Georgia Pacific Toledo / CAO Request for Information Meeting Minutes

May 5 – 6, 2025 / Toledo, OR

This meeting was requested by Georgia-Pacific Toledo (GPT) to discuss two information request letters sent from DEQ CAO regarding the facility's CAO Emissions Inventory.

Photo 5: Building fans above the OCC pulping plant.

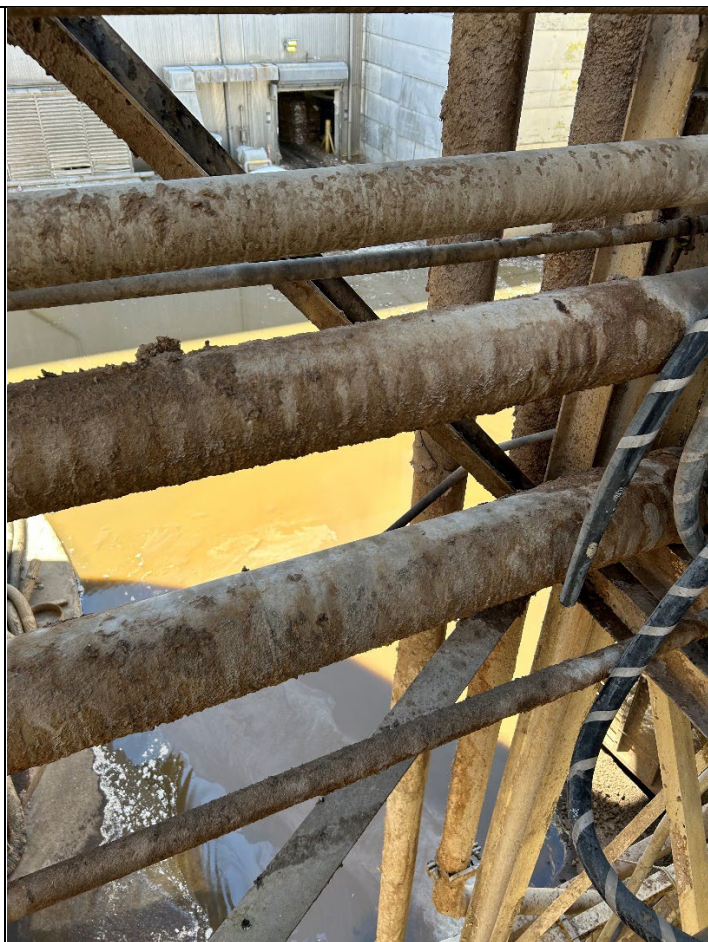
- Paper machines. The team looked at the potential emission locations from these machines. The machines emit into the building and emissions are pulled to roof vents (Photo 1). A vacuum pump on the paper machines is used to pull water out of the pulp throughout the process. The vacuum pump emissions go through a pipe on the exterior of the building with a stack release point above the building roof (Photo 2).
- OCC Pulping plants (Photos 3, 4, and 5). One of the plants was offline. These units emit directly into the building. There were passive fans at the top of the building that could direct some of the emissions. Site personnel states that some of the liquids for the OCC pulping comes from the paper machines.
- Digesters and the blow tanks (Photo 7).
